**DATE:** June 23, 2016

**SUBJECT:** **Petition PB-16-34 SUP:** Greenberg Farrow (John Vecchio, P.E.) agent for Walmart Stores East, owner. A special use permit with an intermediate development plan to allow for the construction of a gas station with convenience store. Zoned: MU-2 (12—30 units/acre mixed use medium intensity). Located at 1800 NE 12th Avenue.

<b>PETITION NO.</b> <b>PB-16-34 SUP</b>	<b>DATE PLAN RECEIVED:</b> 04/19/2016	<b>REVIEW TYPE:</b> <input checked="" type="checkbox"/> Prelim Dev <input checked="" type="checkbox"/> Final Dev <input type="checkbox"/> Amendment <input type="checkbox"/> Special Use <input type="checkbox"/> Planned Dev <input type="checkbox"/> Design Plat <input type="checkbox"/> Concept <input type="checkbox"/> Minor Dev. <input type="checkbox"/> Minor Sub. <input type="checkbox"/> Street Vacation <input type="checkbox"/> Other: Land Use
<b>REVIEWING BODY:</b> Technical Review Cmt.	<b>REVIEW DATE:</b> 05/02/2016	
	<b>REVIEW LEVEL:</b> N/A	
<b>PROJECT DESCRIPTION:</b> <u>Petition PB-16-34 SUP</u> Greenberg Farrow (John Vecchio, P.E.) agent for Walmart Stores East, owner. A special use permit with an intermediate development plan to allow for the

SHEET NO. C-1

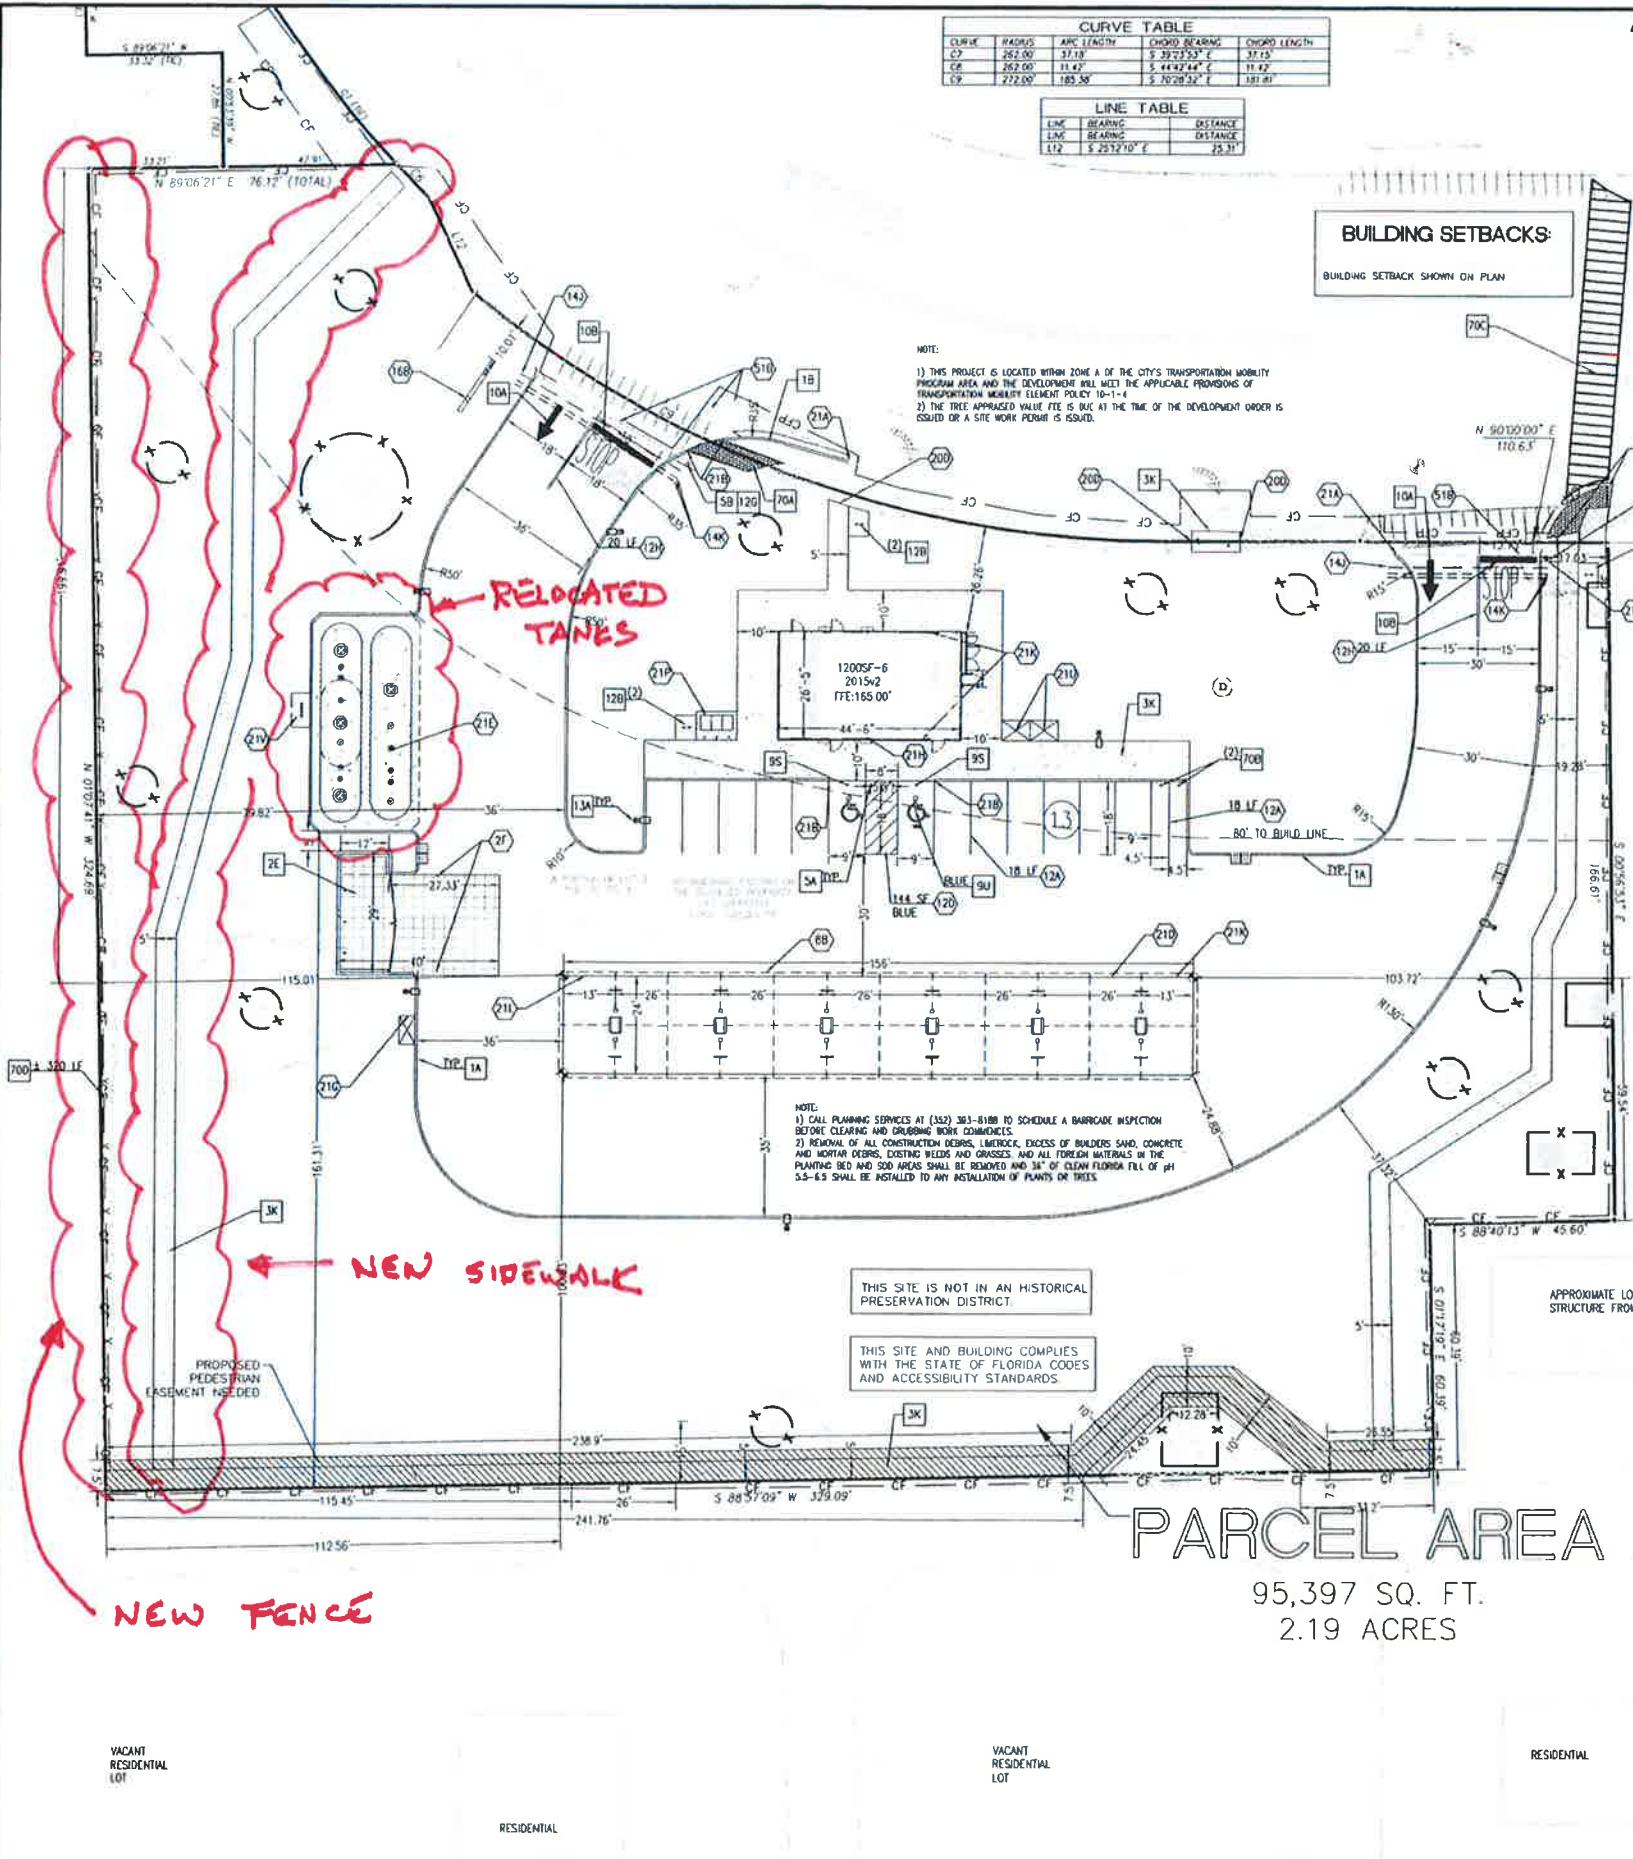
Since the May 26, 2016 meeting, staff reviewed some modifications to the design of the site and hosted a meeting with the neighbors and the applicant. The map included in Attachment "B" shows the proposed modifications and Attachment "A" includes information about the public notices.

REV-2 C-0

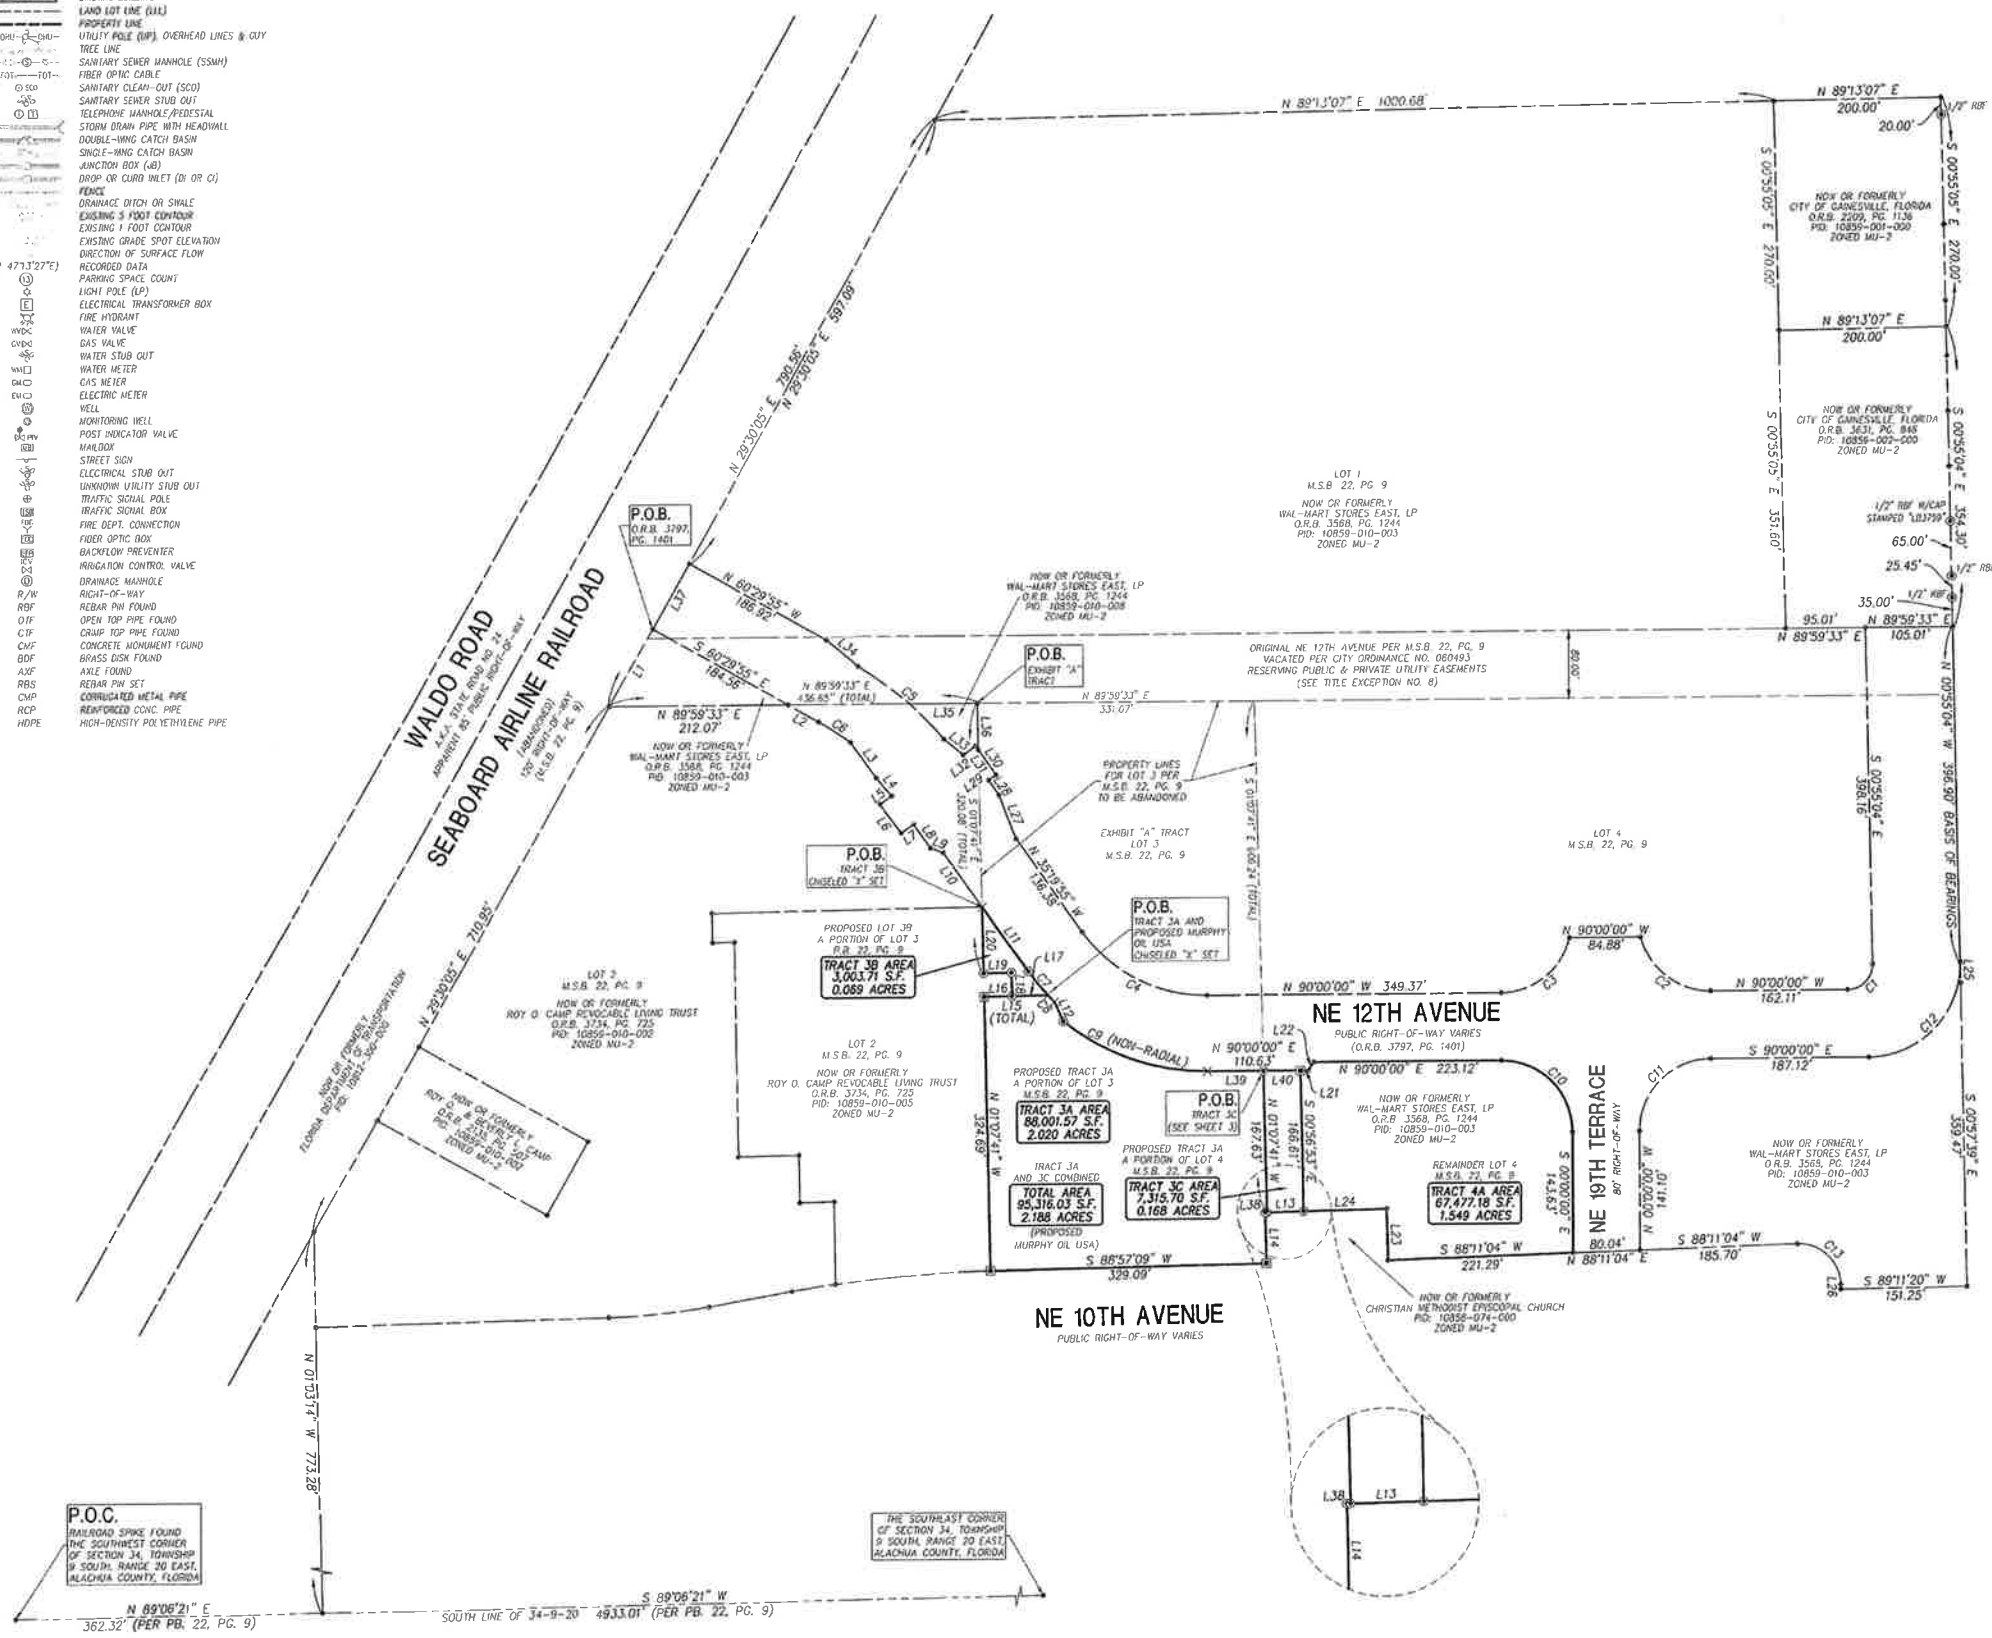
1 - The stormwater management facility is a wet detention system. The retention volume would be the volume retained between the permanent pool volume elevation and the lowest discharge elevation. Please correct the appropriate values on the cover sheet.

C-1

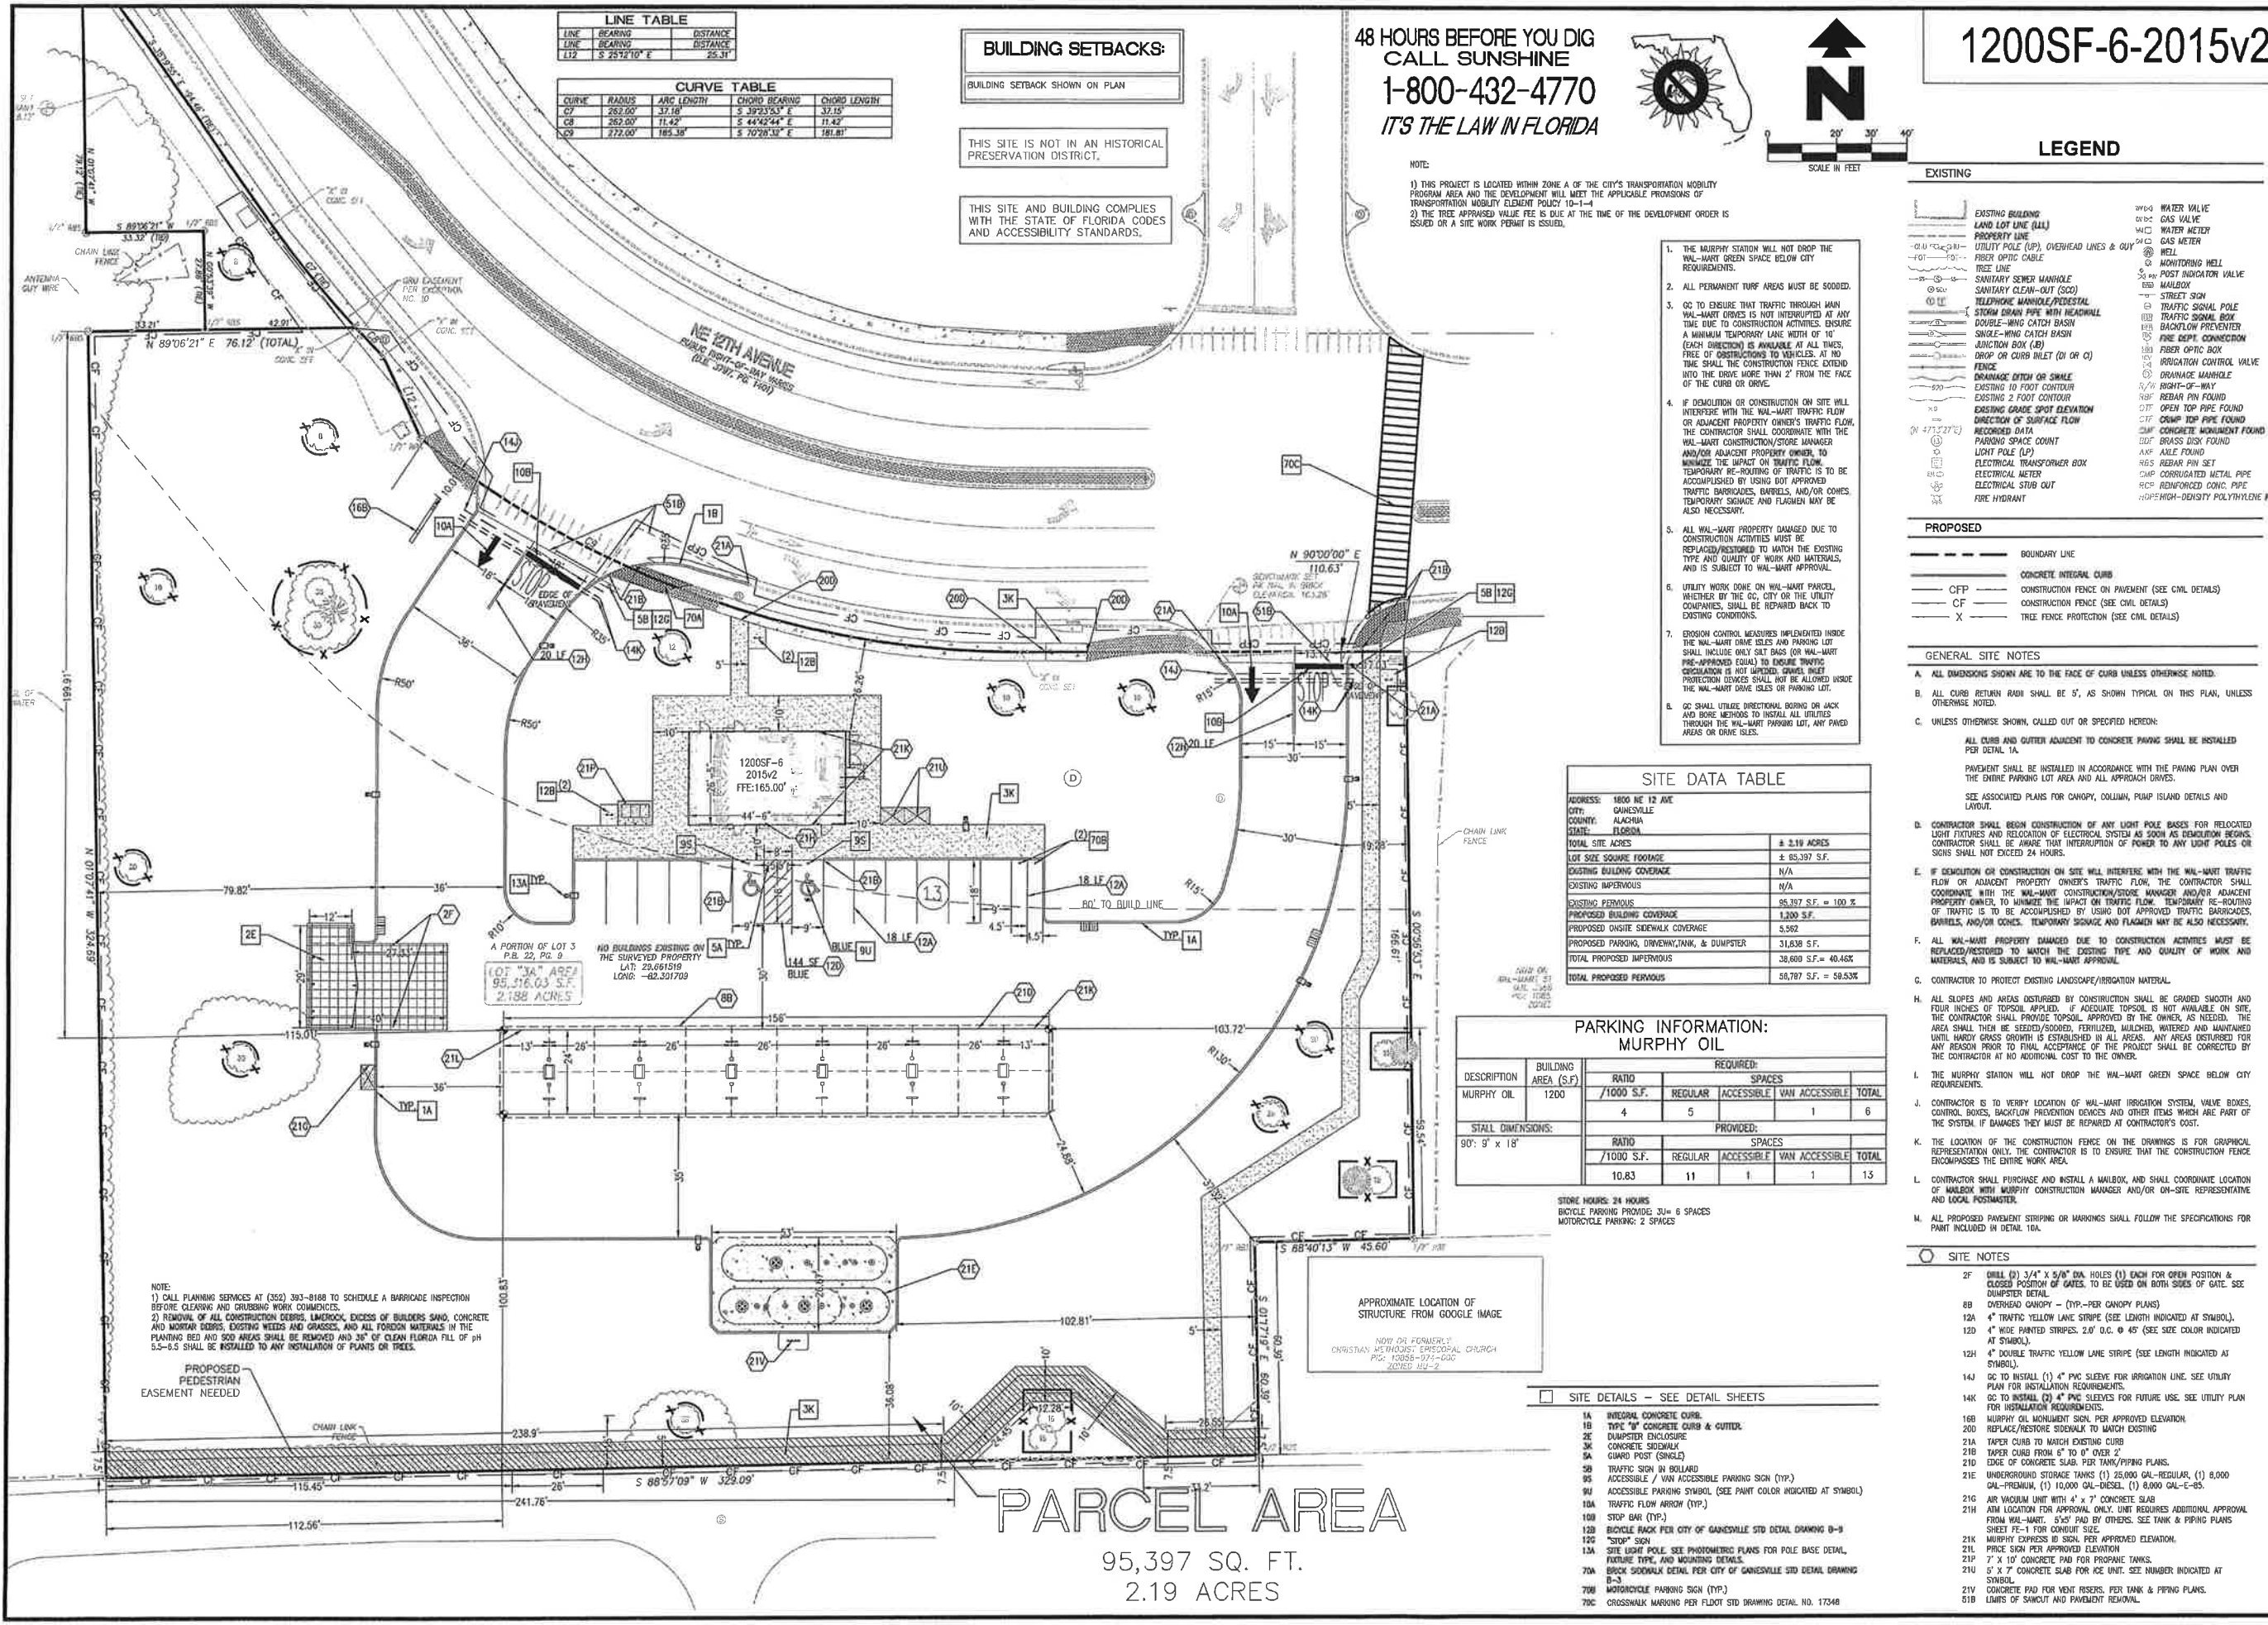
1. Please add the trip generation numbers for the gas station onto sheet C-1 and site the traffic study for the Walmart as the source.
